Access Compliance Report

Public Rights-of-Way

Intersection ID: 10019918	Main Street: ARDREY_KELL_RD	Cross Street: N/A	Location: NE
ADA ID: 0F2A6DA88AFC	Ramp Type: BlendTrans1	Initial Pass/Fail: Fail	Overall Compliance: No
Severity Score: 12.5			
Codes/Mitigation Info/Possible Solution		Field Measurements/Component Compliance

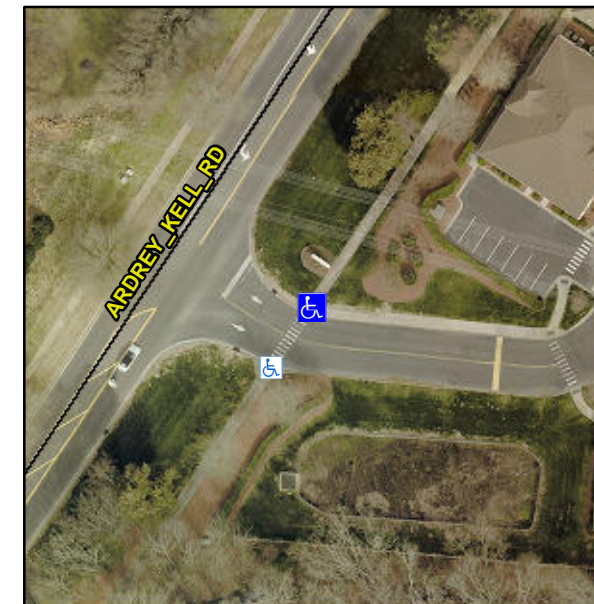
Not Found, R304.5.3

Compliance	Description	Data	Compliance	Description	Data
N/A	Ramp Length (in)	60.0	Yes	BlendTrans Slope (%)	3.6
Yes	Ramp Width (in)	69.0	No	BlendTrans XSlope (%)	6.6
N/A	Flare Type LT	N/A	N/A	Flare Type RT	N/A
N/A	Flare Slope LT (%)	N/A	N/A	Flare Slope RT (%)	N/A
N/A	Flare Traversable LT?	N/A	N/A	Flare Traversable RT?	N/A
N/A	Landing Length (in)	N/A	N/A	DWS Provided?	N/A
N/A	Landing Width (in)	N/A	N/A	DWS Contrast?	N/A
N/A	Landing Slope (%)	N/A	N/A	DWS Length (in)	N/A
N/A	Landing X Slope (%)	N/A	N/A	DWS Full Width?	N/A
N/A	Landing Curb? (Y/N)	N/A	N/A	DWS Offset (in)	N/A
N/A	Shared Landing?	N/A			
N/A	Gutter Ponding?	N/A	N/A	Gutter Slope (%)	N/A
N/A	Gutter Lip Ht (in)	N/A	N/A	Gutter X Slope (%)	N/A
N/A	Painted X Walk1?	Yes	N/A	Painted X Walk2?	N/A
	X Walk 1 Direction	To SW		X Walk 2 Direction	N/A
	X Walk 1 Width (in)	72.0		X Walk 2 Width (in)	N/A
	X Walk 1 Slope (%)	1.8		X Walk 2 Slope (%)	N/A
	X Walk 1 X Slope (%)	9.4		X Walk 2 X Slope (%)	N/A

Remove & Replace Curb Ramp With Two New Directional Ramps or Equivalent.
